3rd Further Information

Temporary Place of Recreation, Sports or Culture (Hobby Farm, Fishing and Prawning Ground and Barbecue Site), Shop and Services and Holiday Camp with Ancillary Facilities for a Period of 3 Years and Associated Filling of Land in "Agriculture" Zone, Various Lots in D.D. 107, Kam Tin, Yuen Long, New Territories

(S.16 Planning Application No. A/YL-KTN/1049)

Responses-to-Comments

Dwg No:
 Fig.3

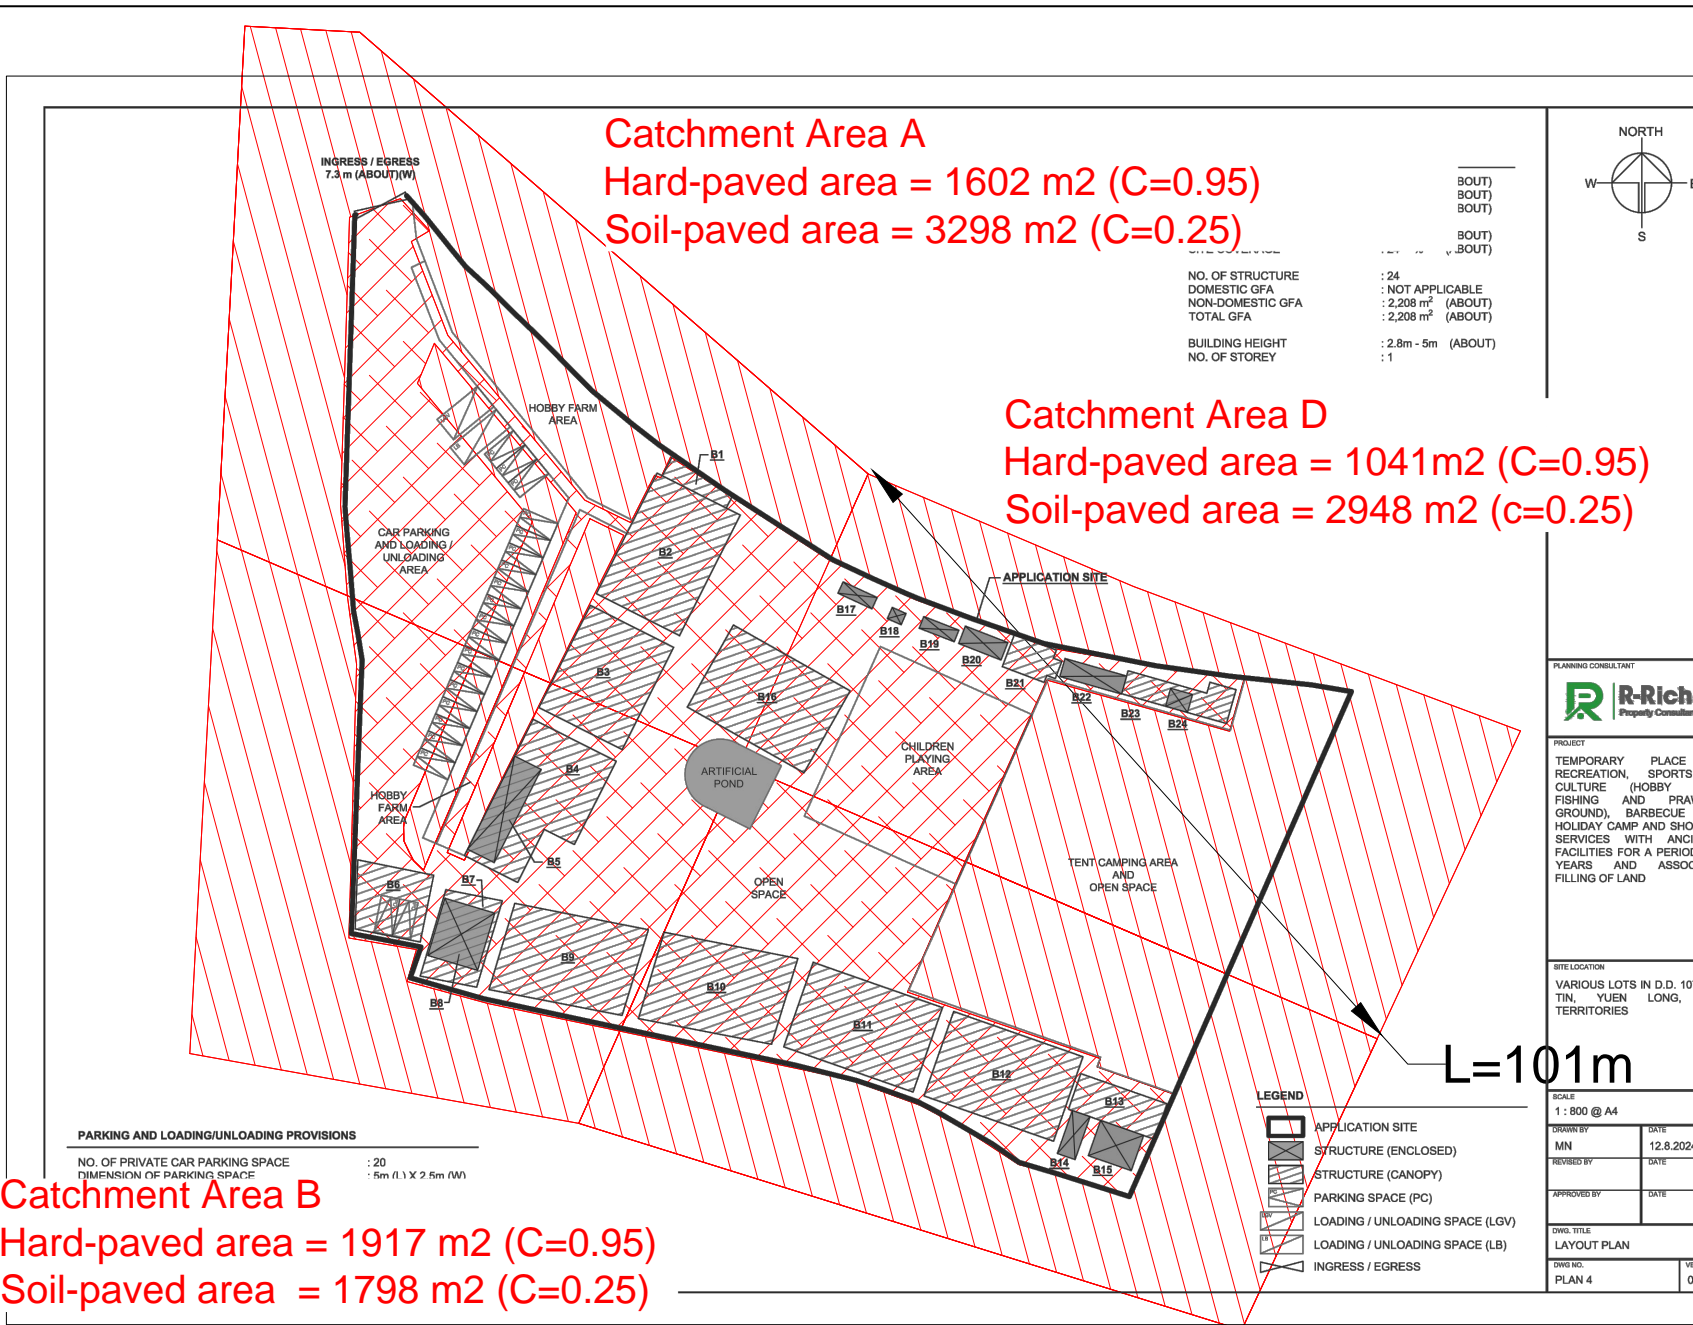
| Departmental Comments | | Applicant’s Responses |
|--|--|--|
| (e) | Please justify the proportion of hard paved and soil paved areas in the calculations, and clearly show the proportion in catchment area drawing. | The proportion of hard-paved and soil-paved are revised and presented in the proposal. |

Catchment Area A
 Hard-paved area = 1602 m² (C=0.95)
 Soil-paved area = 3298 m² (C=0.25)

Catchment Area D
 Hard-paved area = 1041m² (C=0.95)
 Soil-paved area = 2948 m² (c=0.25)

Catchment Area B
 Hard-paved area = 1917 m² (C=0.95)
 Soil-paved area = 1798 m² (C=0.25)

Catchment Area C
 Hard-paved area = 2021m² (C=0.95)
 Soil-paved area = 2303m² (C=0.25)

Section

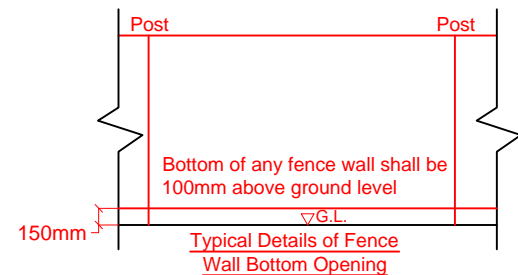
| Departmental Comments | | Applicant’s Responses |
|--|--|--|
| (d) | The ground levels do not tally with available record. Please justify all ground levels indicated in cross sections. | Level justification is presented in the proposal. |

Typical Details of Fence Wall Bottom Opening

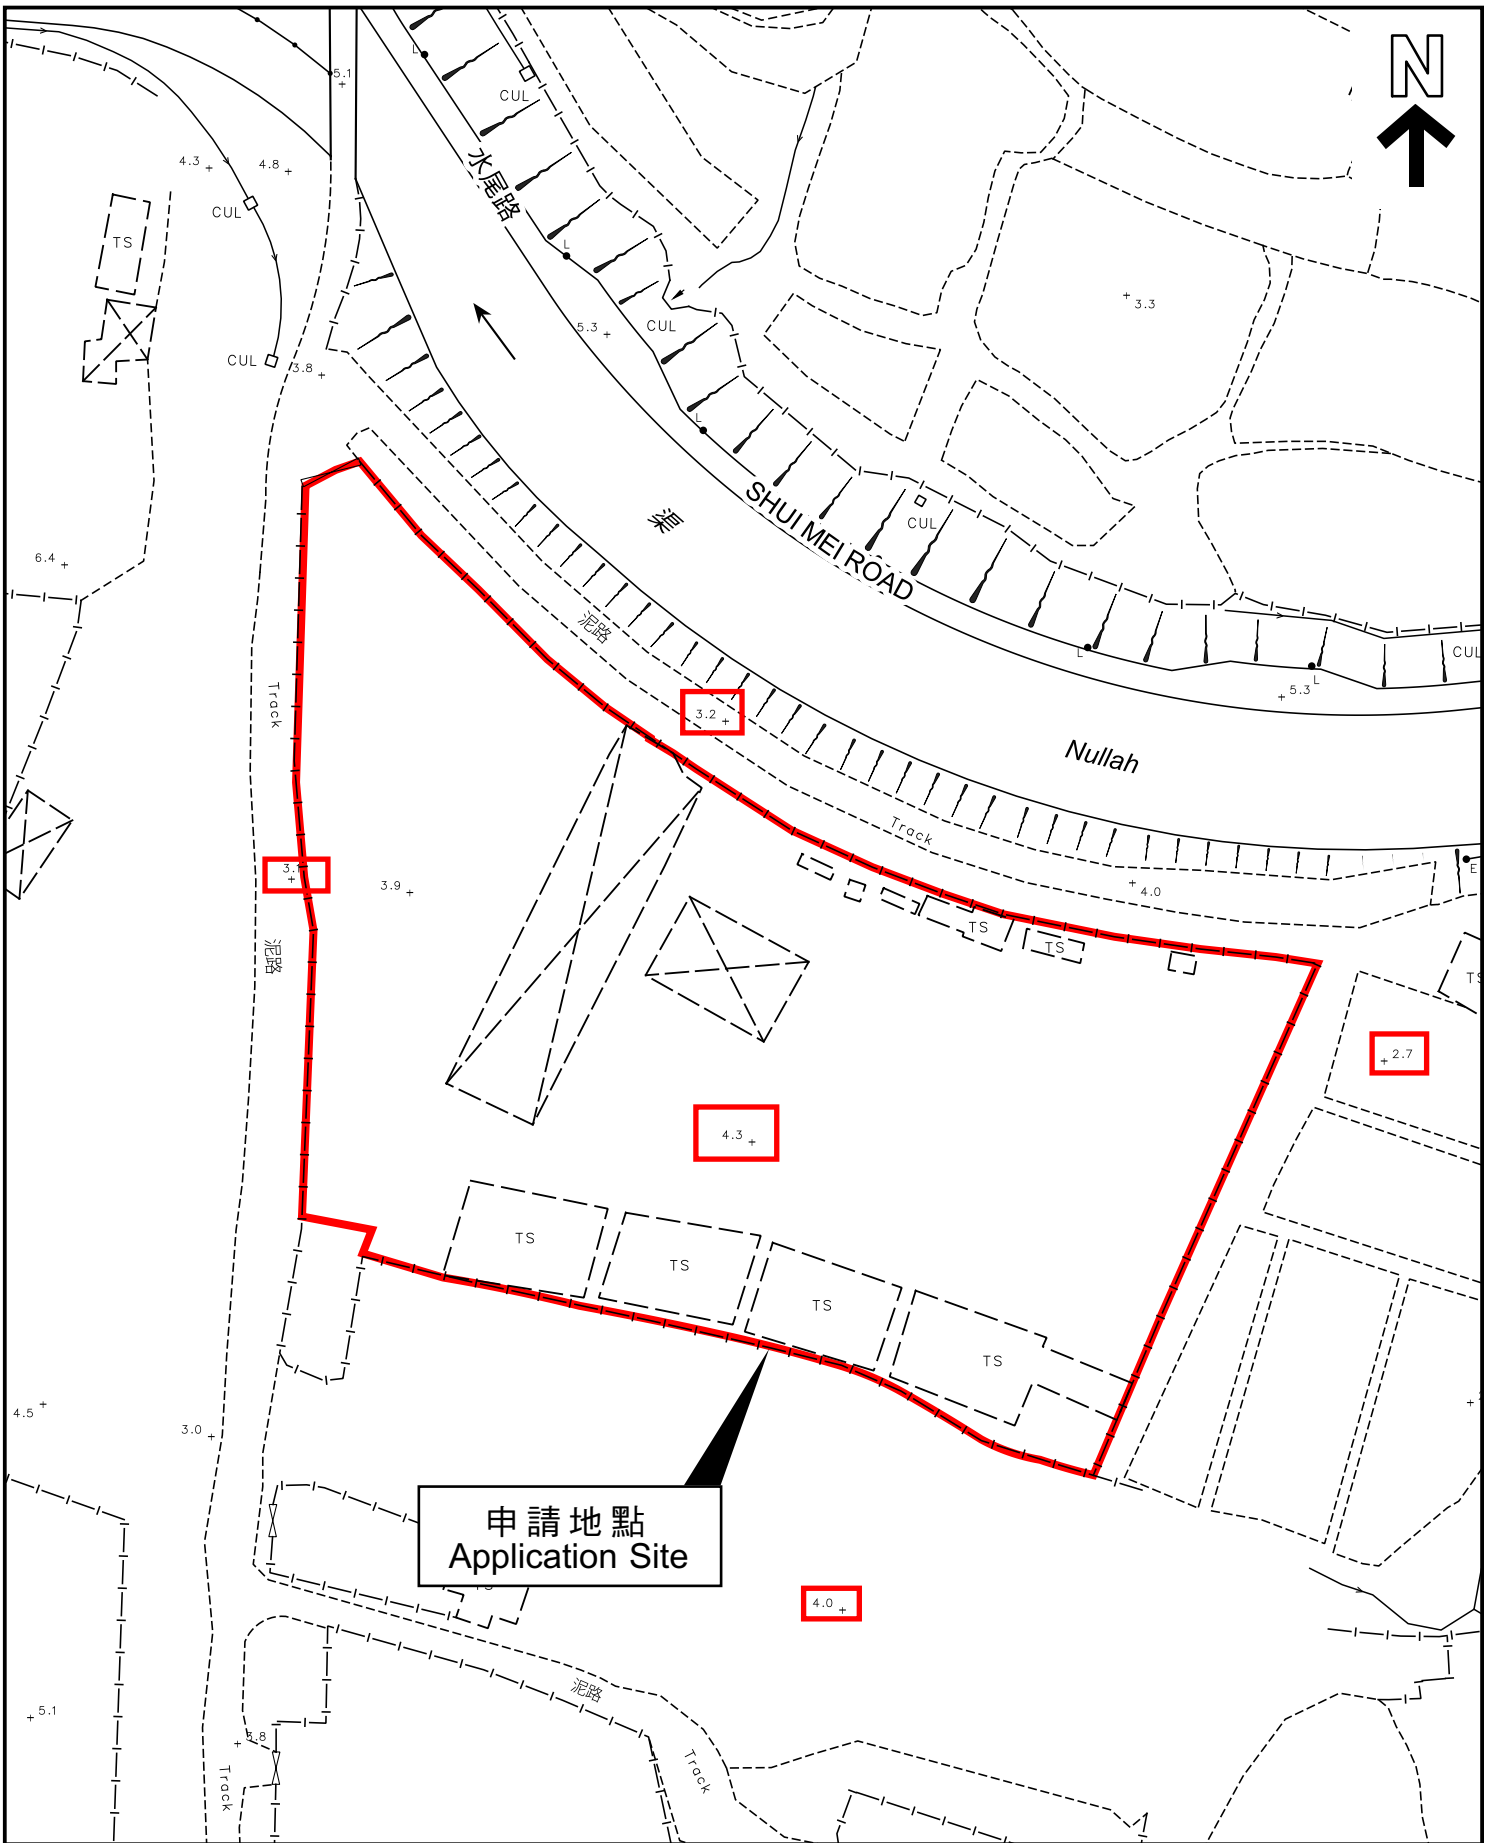
| Departmental Comments | | Applicant’s Responses |
|--|--|--|
| (f) | The opening for fence wall should be along the fence wall bottom without horizontal separation. | Revised accordingly. |

Fence Wall with bottom opening (refer to Typical Details of Fence Wall)

Fence Wall with bottom opening (refer to Typical Details of Fence Wall)
